WASHINGTON PUBLIC POWER SUPPLY SYSTEM

September 17, 1986  
G02-86-0885

Subject: NUCLEAR PLANT NO. 2  
LICENSE NO. NPF-21,  
EQUIPMENT QUALIFICATION AUDIT,  
AUDIT NO. NRC-IR-86-12

#### POTENTIAL ENFORCEMENT/UNRESOLVED ITEM (ROSEMOUNT)

PROCEDURE FOR SEALING CONDUIT  
ENTRY INTO ROSEMOUNT MODEL  
1153 SERIES B PRESSURE TRANSMITTER

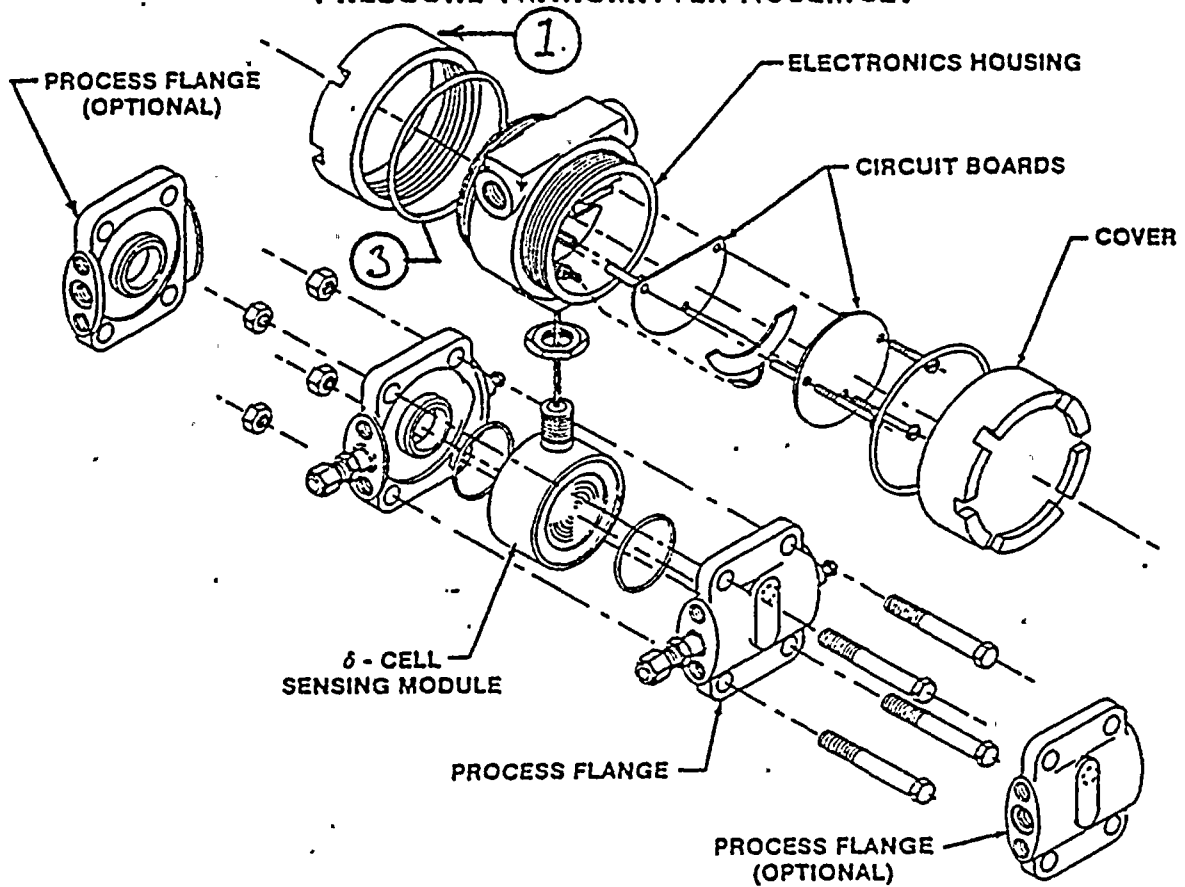
SEAL CONDUIT ENTRY TO THE FOLLOWING  
ROSEMOUNT 1153 PRESSURE TRANSMITTERS  
IN ACCORDANCE WITH ATTACHED PROCEDURE  
SHEETS 0043005 OF THIS DCP.

ON <sup>ALL</sup> PRESSURE TRANSMITTERS *except* REA-DPT-1A1, 1A3, 1B2

~~CIA-PT-21A & 21B~~ APPLY  
DOW CORNING SILICONE FOME  
IN THE CONDUIT AT THE  
FIRST TERM BOX.

1. Remove cover (part 1 of Fig. 1) to allow access to wiring terminals and conduit entry cavity (Area 2 of Fig.1).
2. Prepare and apply Dow Corning 3-6548 silicone foam to fill the wire entry cavity and into the conduit entry, taking care to separate wires and providing a complete seal to the cavity walls and wire surfaces. Preparation and application of the foam material shall be carried out in accordance with PPM 102923.
2. After foam has fully cured, replace seal ring (part 3 of Fig. 1) and replace cover.
